IDAP REPORT

Property:	15 Glenarvon Street STRATHFIELD Lot: 219 DP: 11856 DA2022.121
Proposal:	Demolition of all existing structures and construction of a two storey residence with basement parking and swimming pool
Applicant:	G Al Ali
Owner:	Zaher Hamden
Date of lodgement:	22 July 2022
Notification period:	27 July 2022 – 10 August 2022
Submissions received:	2
Assessment officer:	W van Wyk
Estimated cost of works:	\$1,865,881
Zoning:	R2-Low Density Residential - SLEP 2012
Heritage:	No
Flood affected:	No
Is a Clause 4.6 Variation Proposed:	No
RECOMMENDATION OF OFFICER:	APPROVAL

Figure 3: Proposed Basement Plan (Rev C, 5/09/2022)

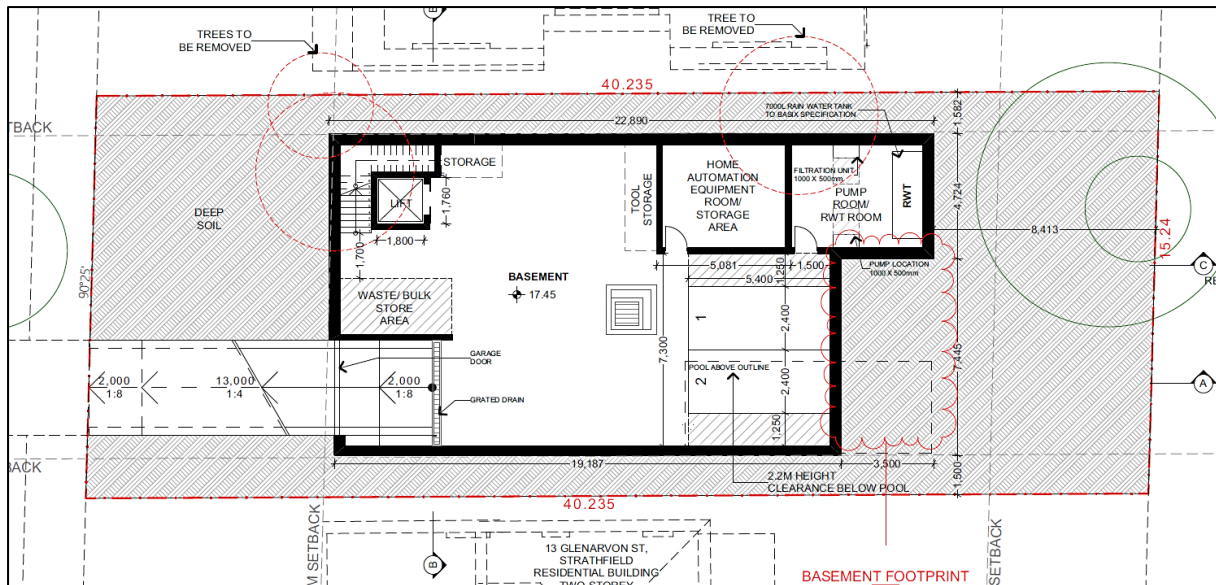
The revised basement is less than 1m above natural ground level after being lowered at the request of Council. While there is an exceedance of the building footprint of the dwelling, this is due to the 'L' shaped design rather than an excessive basement space (see **Figure 19**). The 'L' shape is considered a preferred planning outcome as solar access and visual privacy for 13 Glenarvon Street is enhanced compared to a traditional rectangular building envelope.

Figure 19: Basement and Ground Floor Plan overlay showing outline of building footprint above

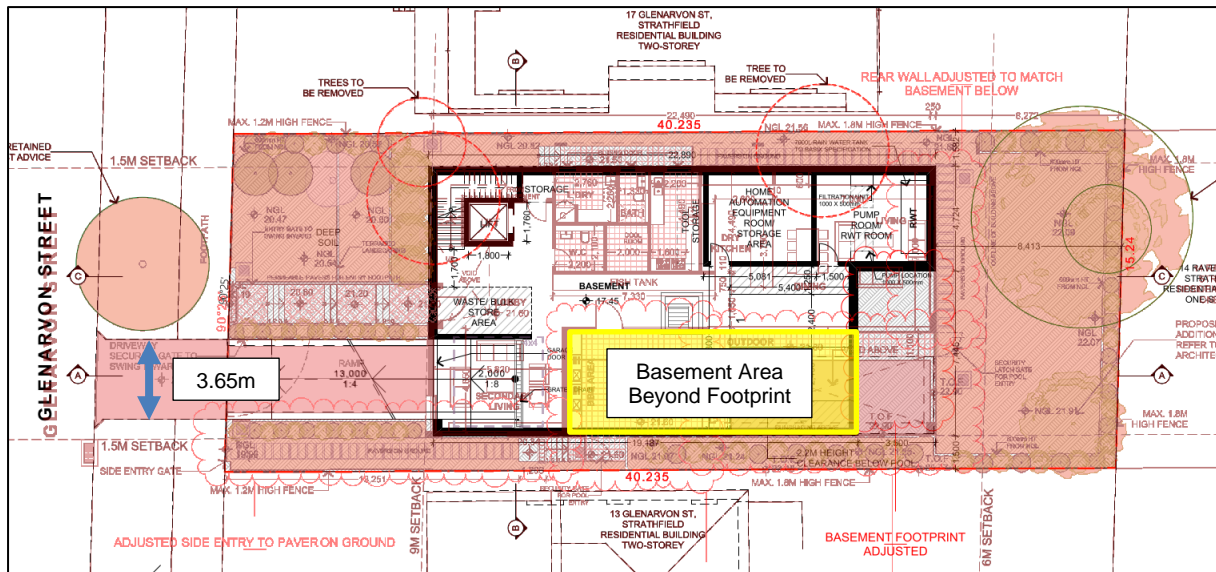
The applicant has provided details on what the basement rooms will be used for and this is considered acceptable. A condition of consent will reduce the floor to ceiling height of the storage and pump rooms to 2.1m. Accordingly, the basement is accepted on merit notwithstanding a breach of the ground floor footprint.

The proposal complies with the 3.5m maximum driveway width within the site, however exceeds the 3m width control at the boundary (see **Figure 19**). This will be reduced to 3m as a condition of consent to comply.
